UPPER GROUND FLOOR PLAN

10 MIXED USE DEVELOPMENT  
LOT 562 TACOMA LANE, MINDARIE

JOB NO. 14.72  
DATE: DEC 2014  
DA 1.2 A  
© COPYRIGHT 2014

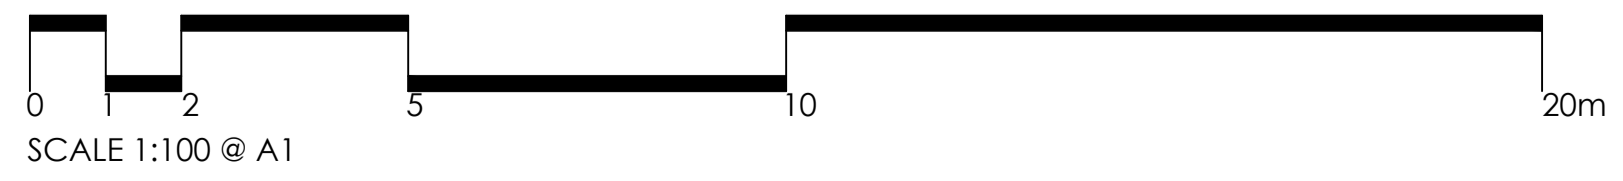
- AMENDMENT A- 10-2-2015
- 1. 'a'- 10 VISITOR BIKE RACKS ADDED.
  - 1. 'b'- VISITOR BAYS RELOCATED. TURNING TEMPLATE ADDED FOR ENTRY & EXIT.
  - 1. 'c'- 10MM GLASS+ SEALS IN COMMERCIAL FRAMES TO DOORS & WINDOWS AS SHOWN FACING MARINA & BOAT RAMP.
  - 2. MAX 750MM HIGH HEDGE TO TACOMA LANE FRONT. 'ROSEMARY' OR 'AFRICAN MYCENAE'.
  - 3. BINS COLLECTED BY PRIVATE CONTRACTOR.
